BARANGAROOSOUTH

PLANNING AND ENVIRONMENT RESPONSE – BAR418–SB-98

JULY 2017

View Corridors across Hickson Park

Hickson Park View 1

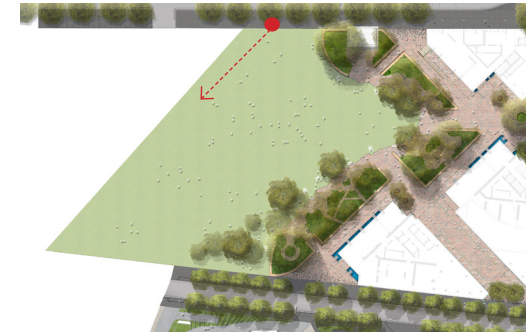
‘Provide further analysis and discussion oh how view corridors from Hickson Road to Sydney Harbour would be provided across Hickson park with the proposed final levels and grading’.

Studies have been developed to capture the view corridors from Hickson Road to the harbour reflective of proposed levels.

View lines have been captured at eye height (1700mm).

Clear and unimpeded views to Central tree allee’ have been maintained.
